ADDENDUM #4

North Carolina Aquariums
Jennette's Pier Decking Repair and Replacement
SCO ID# 22-25352-01A

Addendum #04
North Carolina Aquariums
Jennette's Pier
Decking Repair / Replacement
Nags head, North Carolina

- Item 4 Drawings – Sheet A3.0** has been revised and reissued (see **Attachment #2**).
- #1/A3.0 Typical Pier Section: Detail tags have been updated to reference details on sheet A3.2. Size of continuous FRP support has been changed from 3x3 to 3-1/2"x3.

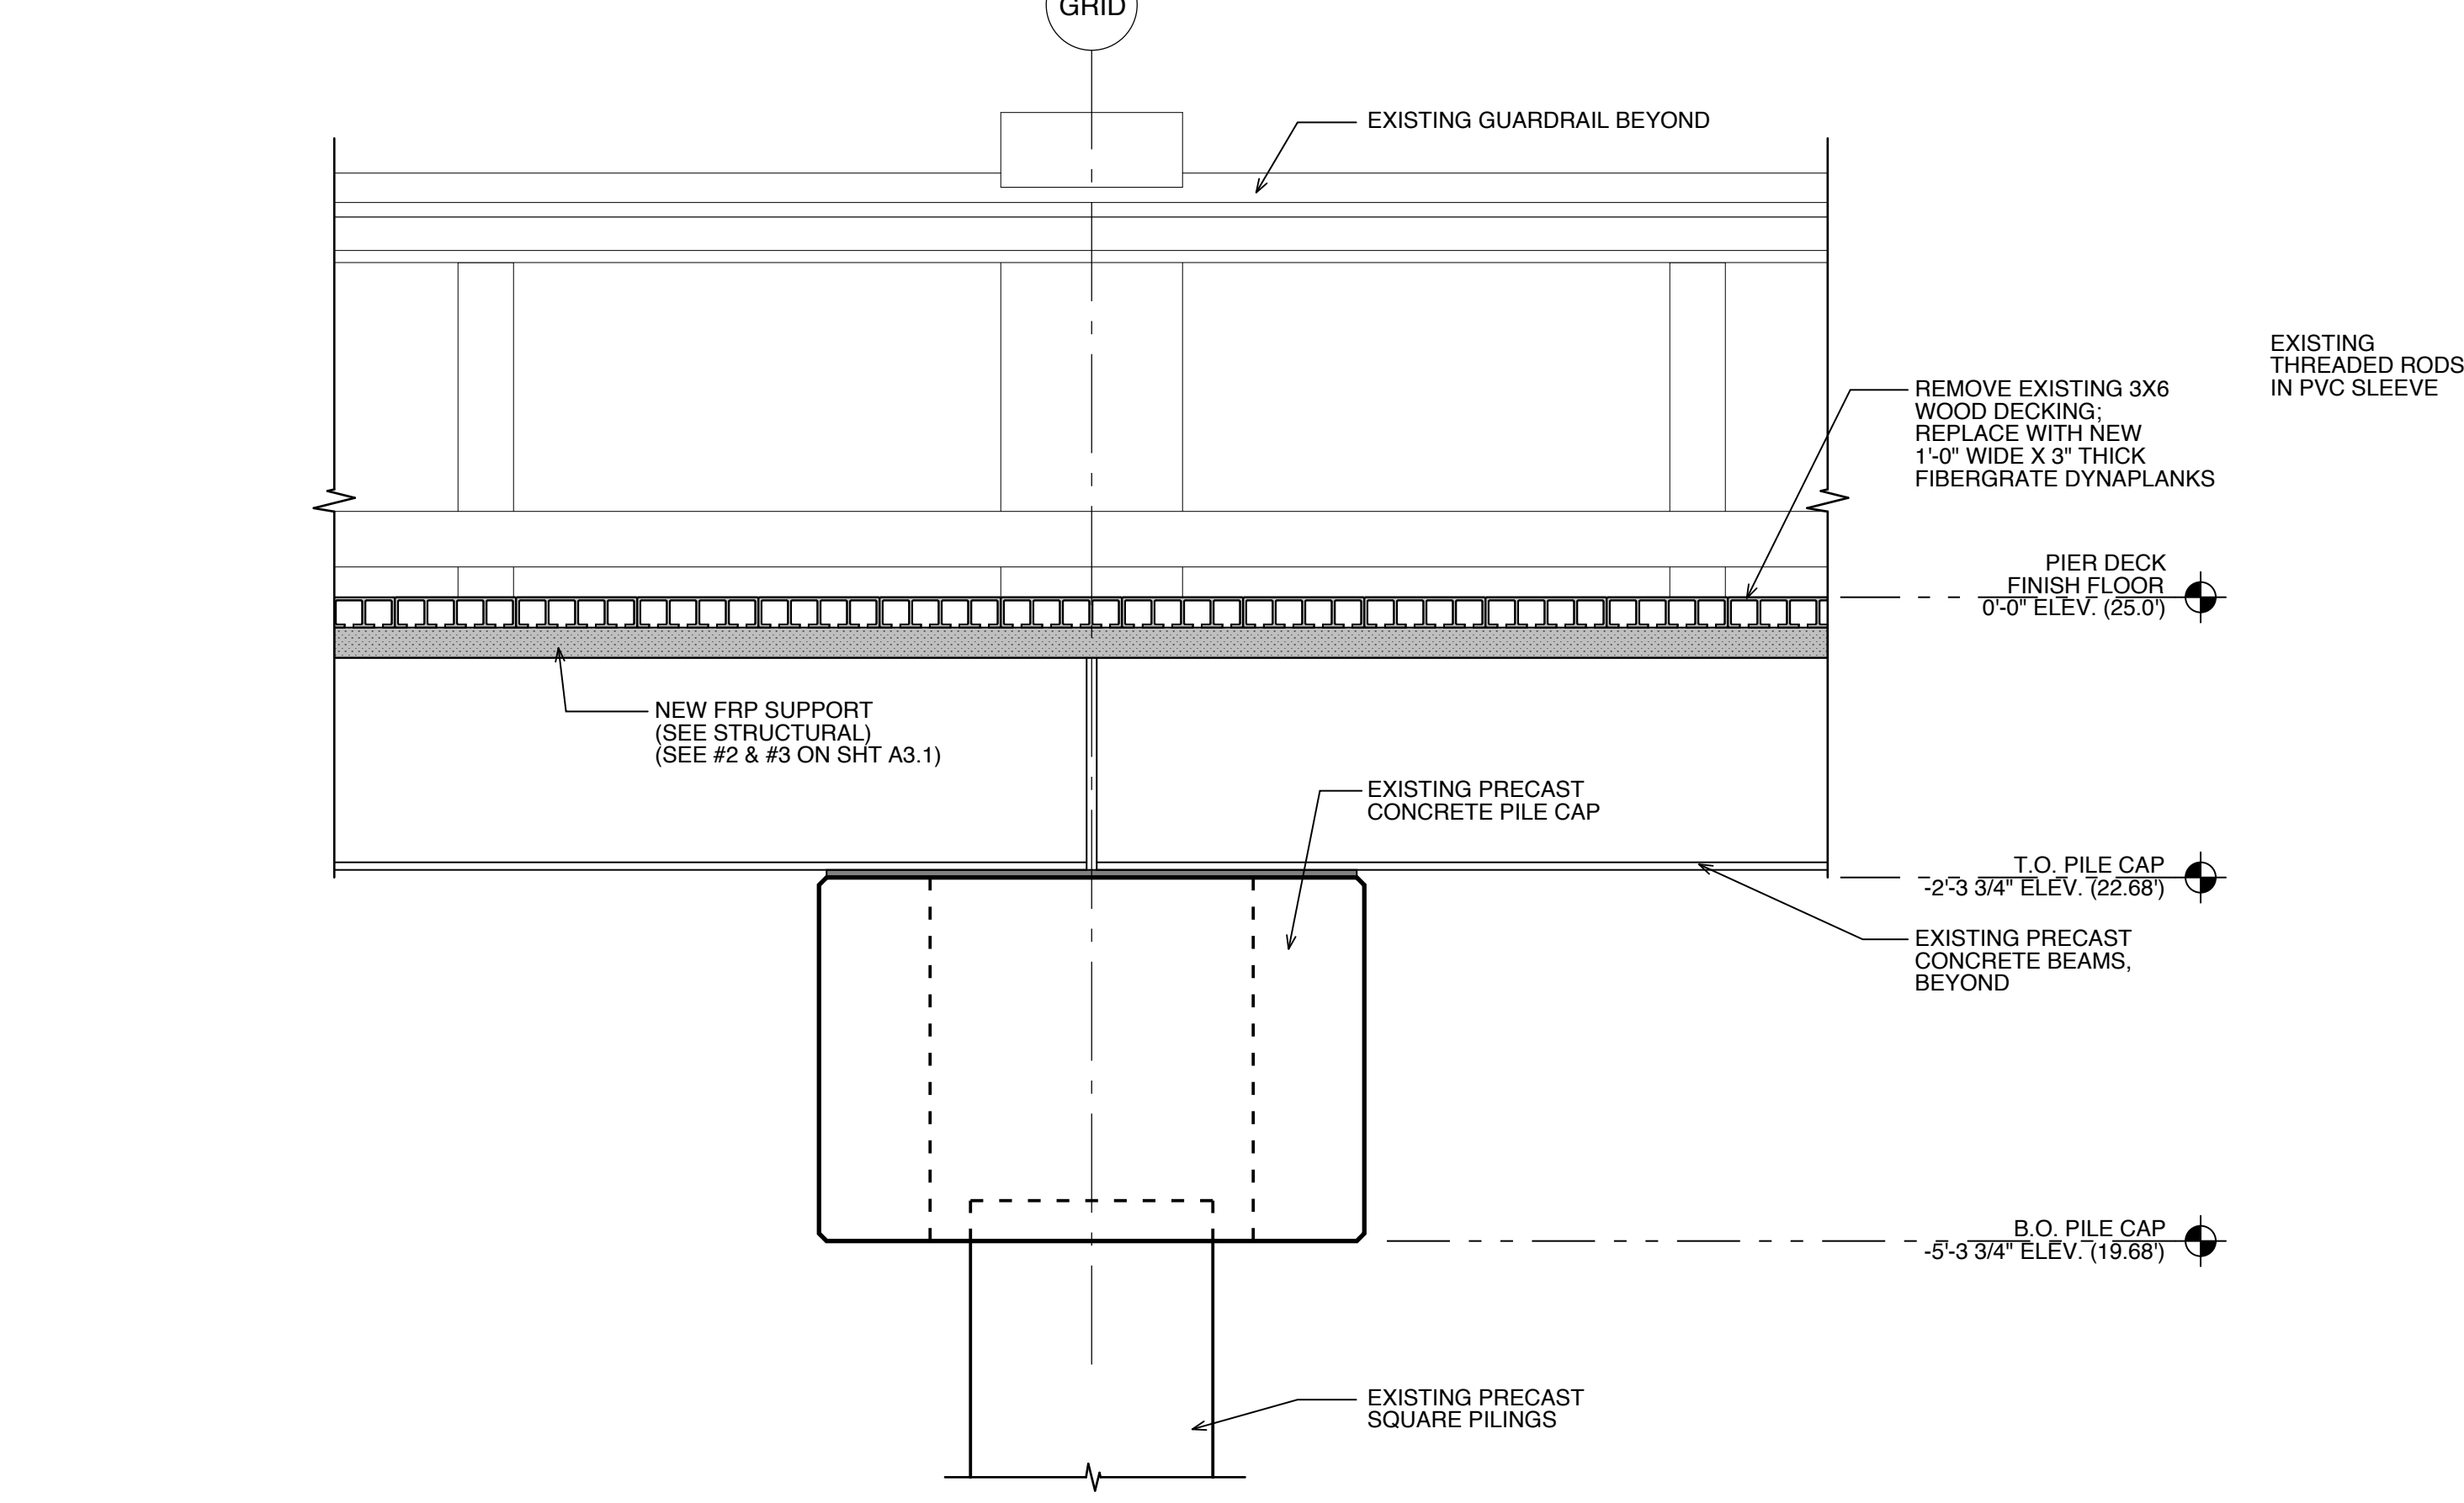
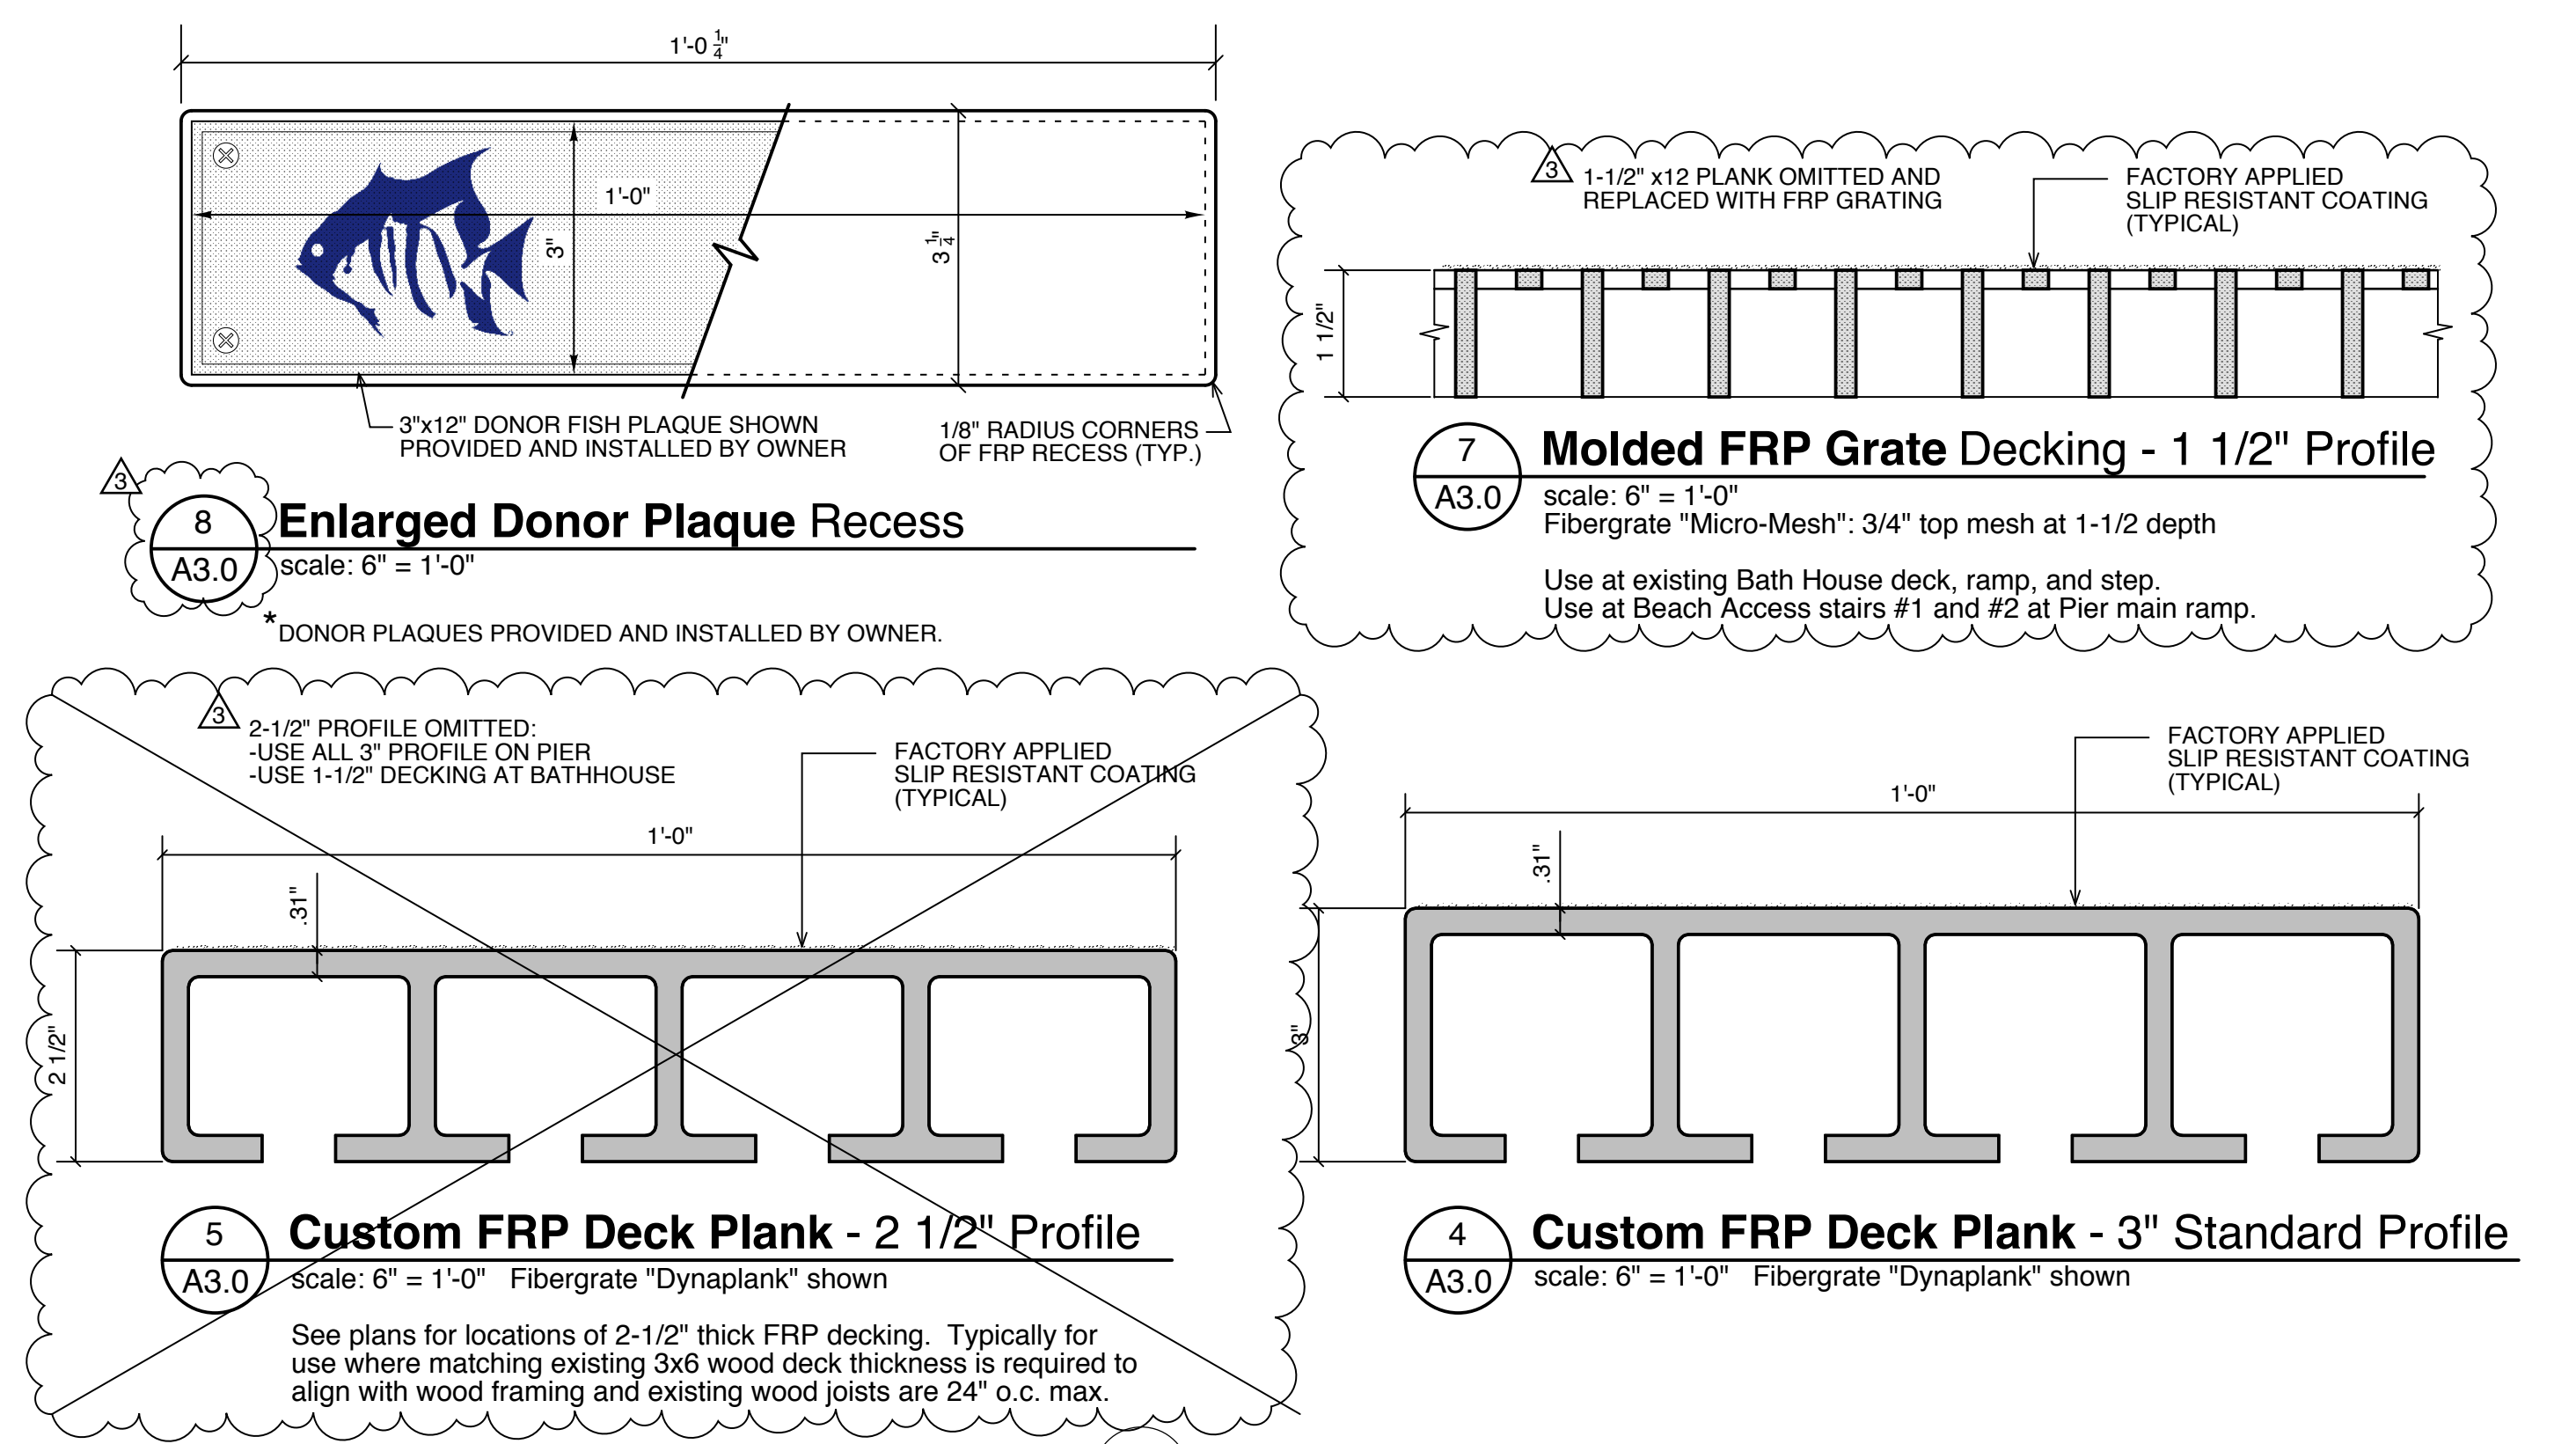
- Item 2** **Drawings – Sheet A2.0** been revised and reissued (see **Attachment #1**).
- a. #1/A2.0 Enlarged Plan now shows 1-1/2" FRP grating at Beach Access stairs #1 & #2. Additional notes have been added at these stairs.

- b. #1/A2.0 Enlarged Plan; notes regarding 2-1/2"x12" FRP planks at start of ramp has been changed to 3"x12" FRP planks.
 - c. #1/A2.0 Enlarged Plan; Location of delineation line between wood framing and concrete has been moved to correct location.

- d. Plan #2/A2.0 Enlarged Bath House Decking; Decking material has changed to 1-1/2" FRP grating. FRP decking shall be used on deck, stairs and ramps. (stairs not hatched for clarity.)

- e. #3/A2.0 Step Detail; Treads and Risers have been changed to 1-1/2" FRP grating. In addition, P.T. wood framing shall be provided on stairs and landing to raise FRP grating to meet top of new FRP decking.

- f. Decking LEGEND has been revised to include the 1-1/2" FRP grating.
- Item 3** **Drawings – Sheet A2.1 and A2.2:** Triangular deck areas supported by wood framing as noted will receive same 3"x12" FRP deck planks as provided in surrounding areas. Disregard notes and legends indicating the use of 2-1/2"x12" FRP planks in these areas. The top of existing wood joists and timber support framing shall be trimmed in place approximately 1/2" to align with top of new FRP ledgers.
